1. 7:00 P.M. Planning Commission October 2020 Regular Meeting

Agenda
Planning Commission - Virtual Meeting
Wednesday, October 21, 2020 – 7:00 P.M.

- Medical & Recreational Marihuana Zoning Text Amendments.
 - Public Hearing
- Site Plan Review: Avenue Market at 902 W Michigan.
- Special Use Permit & Site Plan Review: 201 N Park.
 - Public Hearing

STORM SEWER
PROFILES

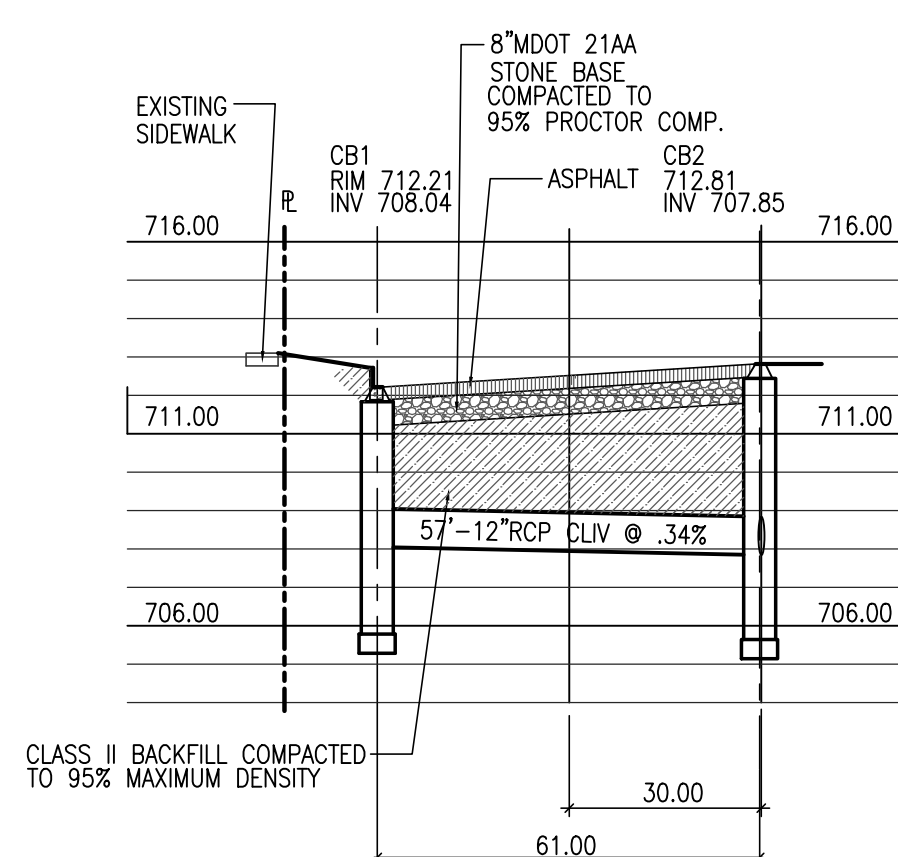
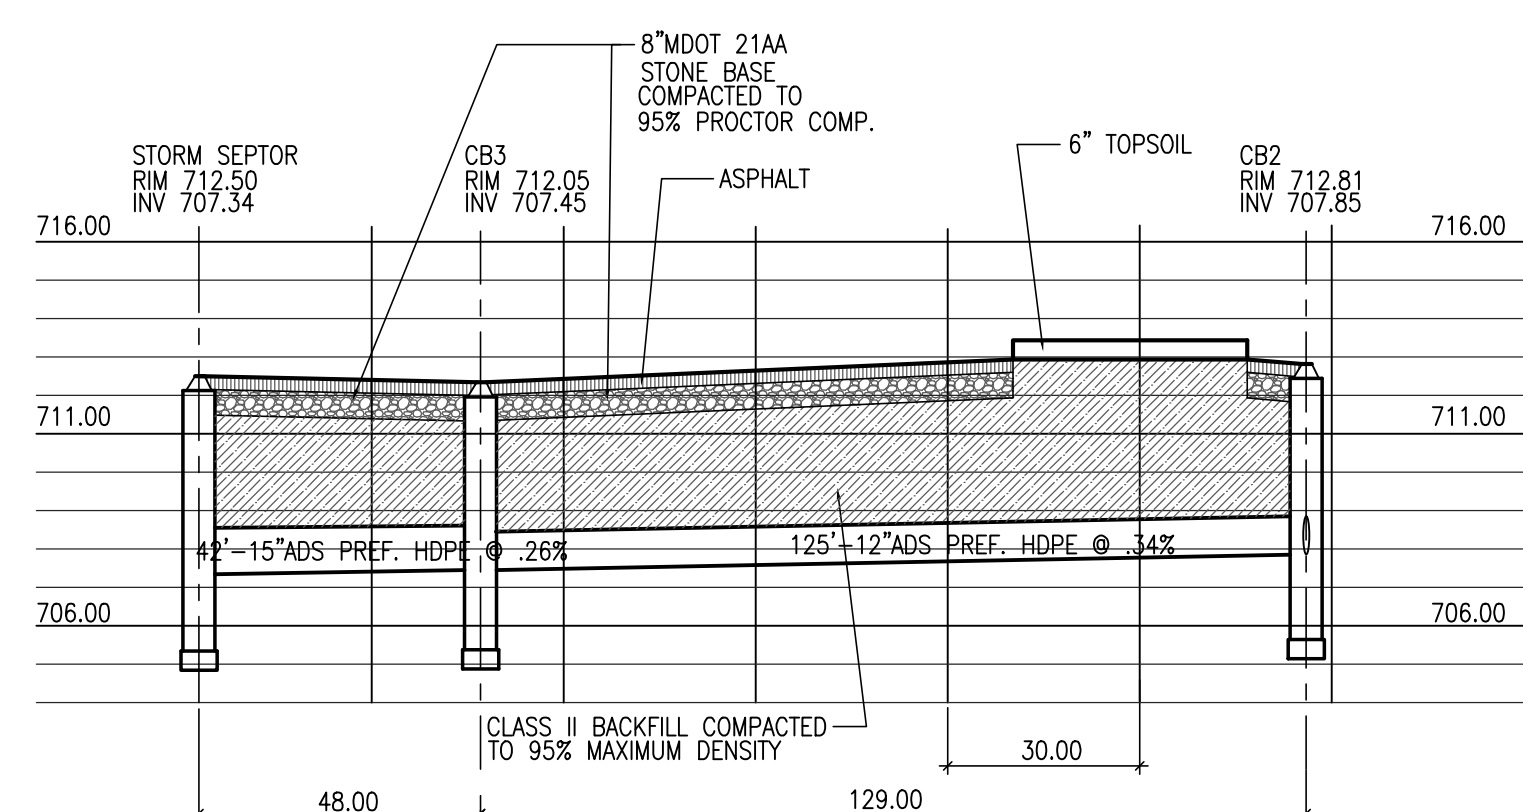
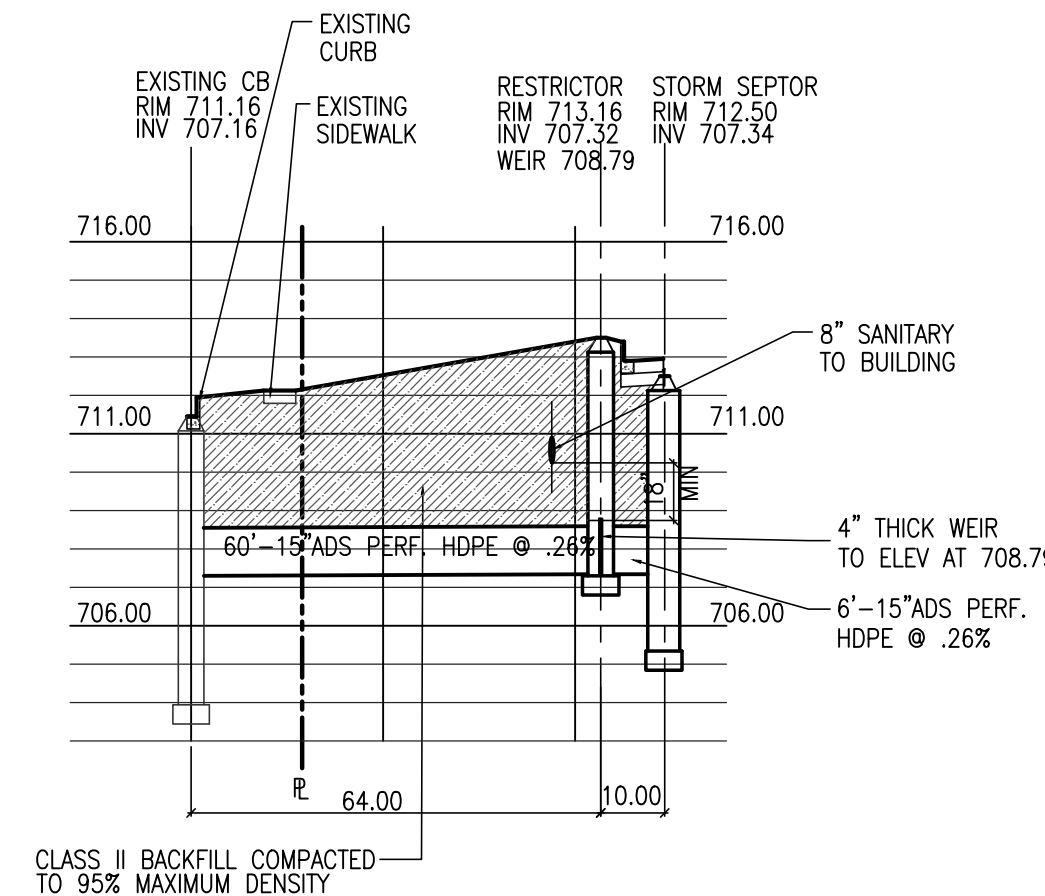
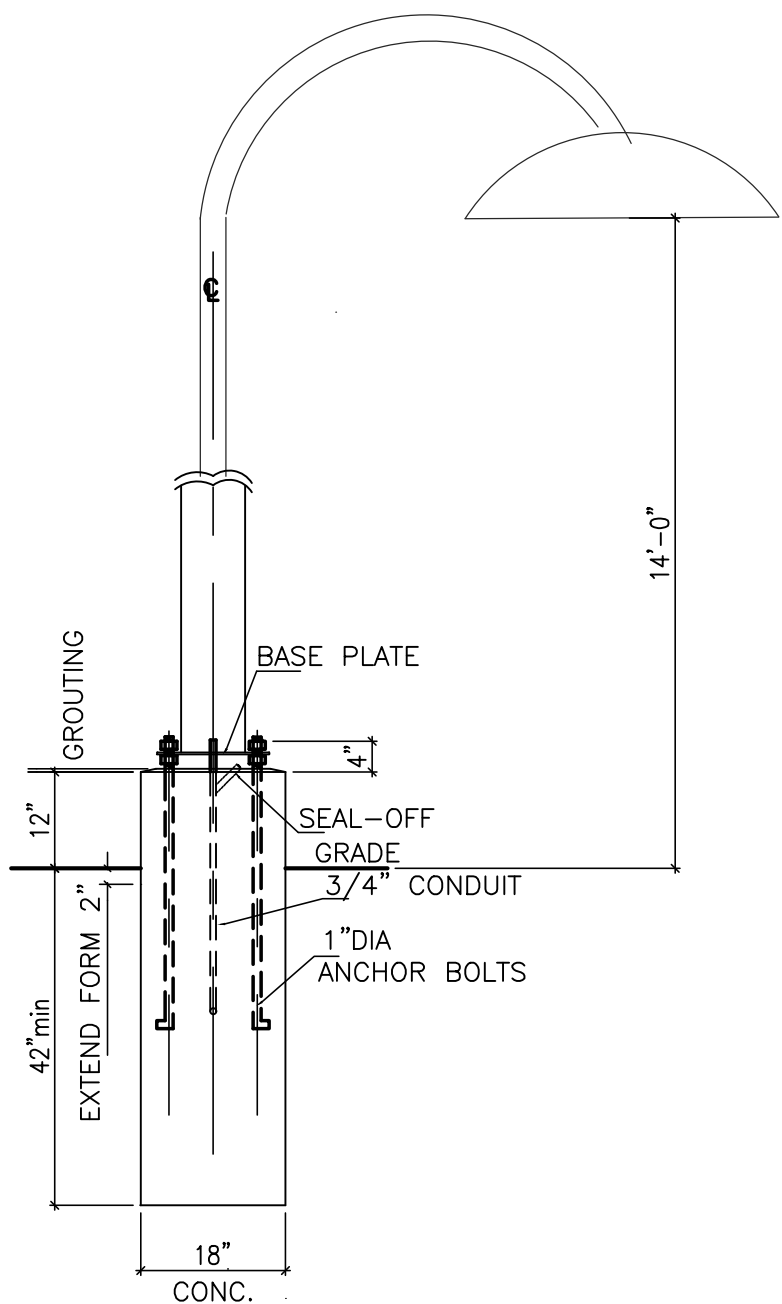
13. Existing sanitary lead to 201 N Park Street shall be shown on the drawings.
14. Storm sewer profiles show 8-inch MDOT 22AA stone base under asphalt pavement, but the asphalt detail has 6-inch 21AA aggregate base. Please clarify which section is proposed.

14. Storm sewer profiles show 8-inch MDOT 22 AA stone base under asphalt pavement, but the asphalt detail has 8-inch 21AA aggregate base. Please clarify which section is proposed.

**DEMOLITION
SITE PLAN**

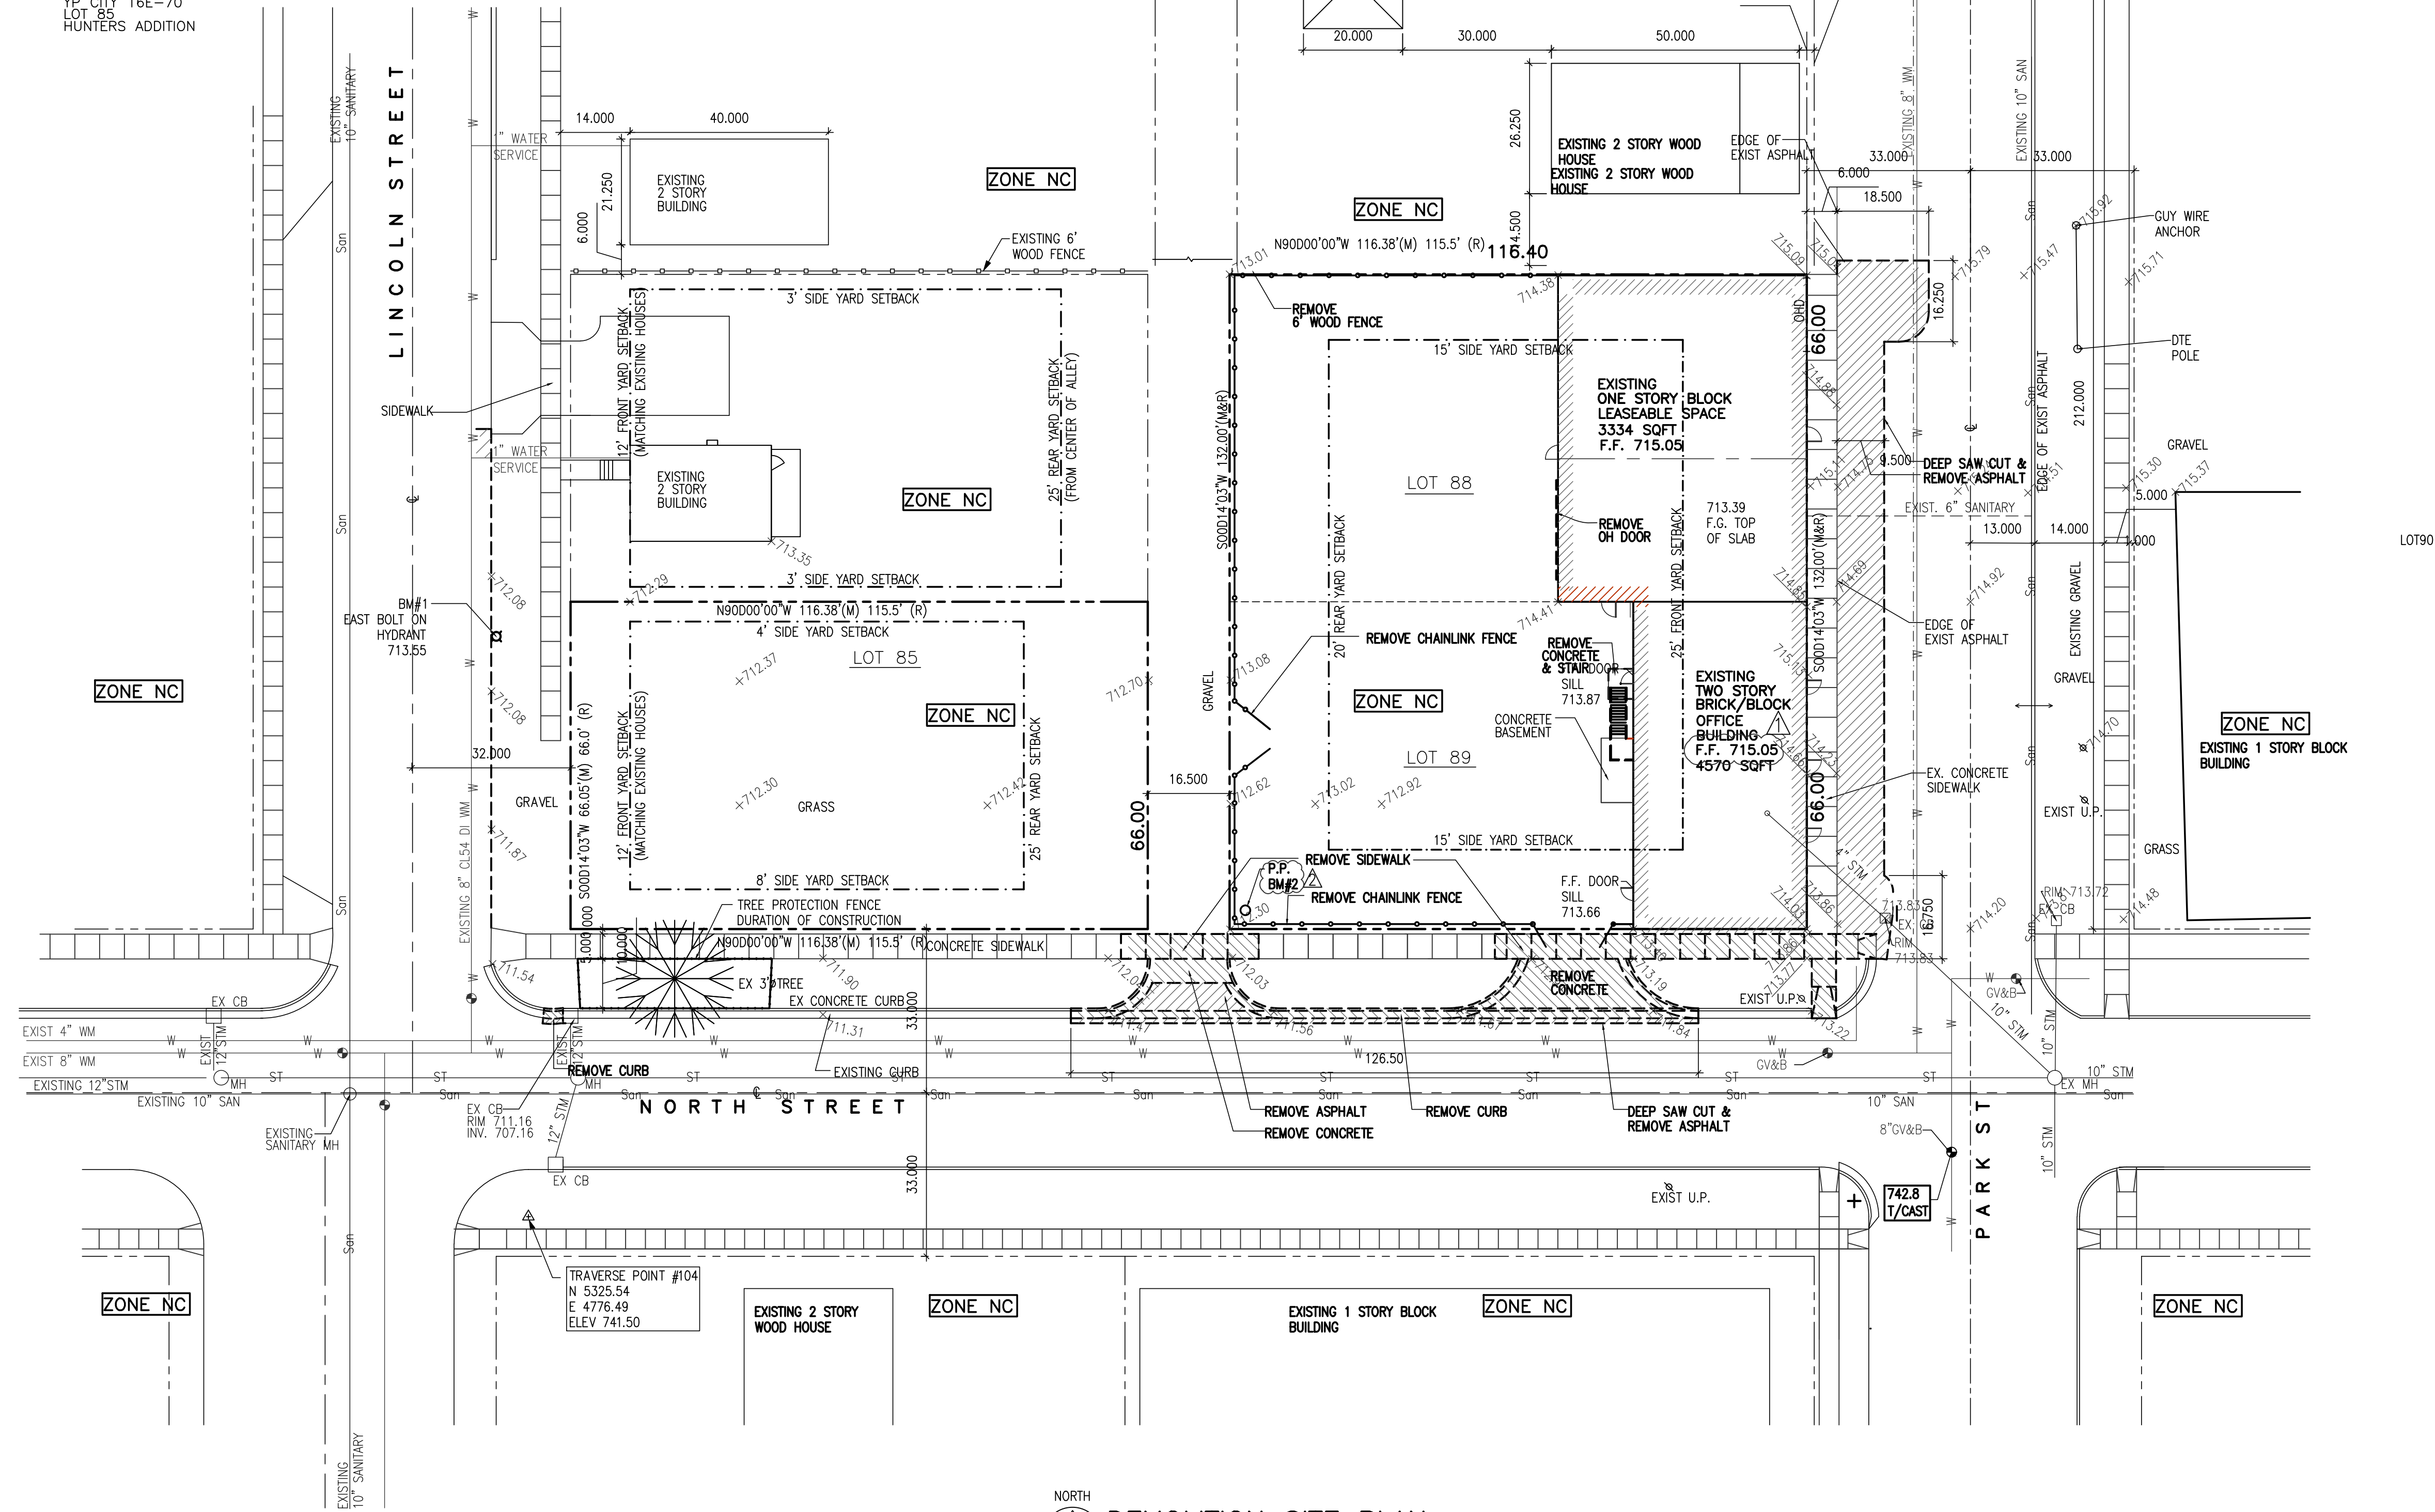
2. On sheet C-2 Demolition Site Plan, the removal hatch should be added to the sheet legend for clarity.
3. On sheet C-3 Site Layout Plan, the proposed surface hatches should be added to the sheet legend for clarity.

2. On sheet C-2 Demolition Site Plan, the removal hatch should be added to the sheet legend for clarity.
 - a. (Answer): Has been clarified.
3. On sheet C-3 Site Layout Plan, the proposed surface hatches should be added to the sheet legend for clarity.
